Aeronautical Study No.
2022-ASO-36103-OE

**** NOTICE OF PRELIMINARY FINDINGS ****

| Structure: | Commercial Use Building Hilton Homewood Suites |

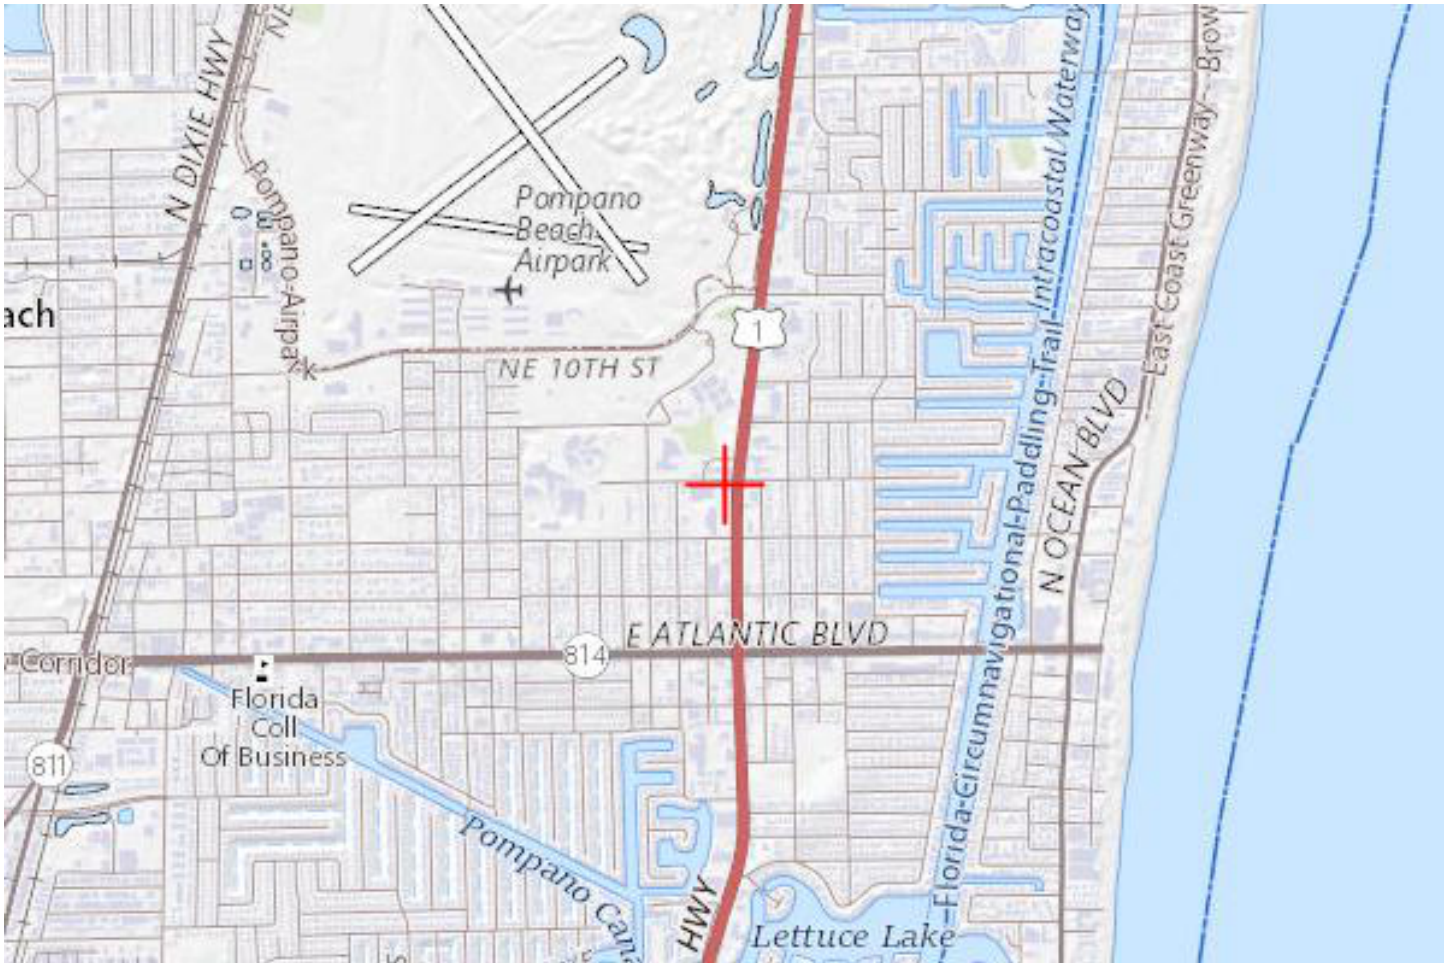
Obstacle penetrates RWY 15 40:1 Departure Surface by 46 feet. Qualifies as low, close-in penetration with climb gradient termination altitude 200 feet or less above DER, requiring TAKEOFF MINIMUMS AND (OBSTACLE) DEPARTURE PROCEDURES, AMDT 5, TAKE-OFF OBSTACLE NOTES: RWY 15, building 2447 feet from DER, 660 feet right of centerline, NEH: 73 AMSL.

Section 77.19 (e) PMP: Transition Surface. These surfaces extend outward and upward at right angles to the runway centerline and the runway centerline extended at a slope of 7 to 1 from the sides of the primary surface and from the sides of the approach surfaces. Transitional surfaces for those portions of the precision approach surface which project through and beyond the limits of the conical surface extend a distance of 5,000 feet measured horizontally from the edge of the approach surface and at right angles to the runway centerline. The proposal will exceed Runway 15/33 Transition Surface by 30 feet.

If the structure were reduced in height so as not to exceed 64 feet above ground level (73 feet above mean sea level), it would not create a substantial adverse effect and a favorable determination could subsequently be issued.
